UNITED STATES PATENT AND TRADEMARK OFFICE

Office Action Summary	Application No. 10/591,341	Applicant(s) OREN ET AL.	
	Examiner MARK MASHACK	Art Unit 3773

DETAILED ACTION

Fig. 19C

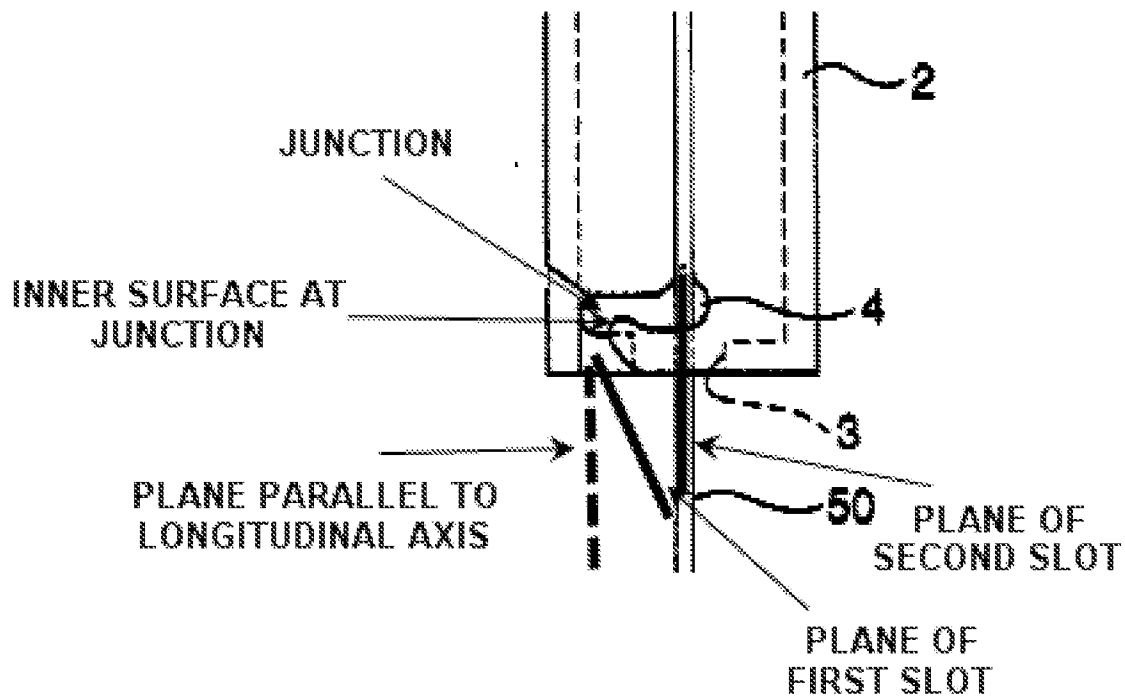
1. Applicant's arguments filed 1/28/2009 have been fully considered but they are not persuasive. Applicant argues that **Furusawa** does not disclose "an open slot extending along the outer surface of the elongate shaft [to] the recess". Examiner disagrees. The slot extends along the shaft as clearly depicts in FIG 19. Applicant argues that **Furusawa** does not disclose that "the open slot is not formed from a first section leading from the recess towards the proximal end of the elongated shaft, and a second section leading from a juncture with the first section towards the distal end of the elongated shaft, but terminating short of the end face". Examiner disagrees. FIG 19 clearly depicts a juncture which separates two sections, the first of which leading from the recess towards the proximal end and a section leading from the juncture toward the distal end of the shaft.

Furusawa discloses an implement for manipulating a knotted suture comprising:
an elongated shaft **2** having a proximal end and a distal end engageable with a knotted suture (FIG 19);

a distal end with a recess **3** for receiving the knot of the suture;

said distal end has an open slot **4, 5** with a first section leading from said recess towards the proximal end and a second section leading from a juncture with said first section towards the distal end but terminating short of the end face. Said first slot section is a three dimensional object and hence has an infinite amount of plane, one of which is in a plane at an angle of 10-30 degrees relative to the longitudinal axis. Said second slot section additionally comprises a plane parrallel to the longitudinal axis of the elongated shaft (FIG 19C). The second slot section can be considered leading towards the distal end but terminating short since it widens towards the distal end after the inner surface of the junction. One segment of the plane of said second slot section is rotated *approximately* 90 degrees with respect to one segment of the plane of said first slot section (FIG 19A). The slots decrease from said juncture toward the distal since the rounded inner surface of the junction juts out into the slots.
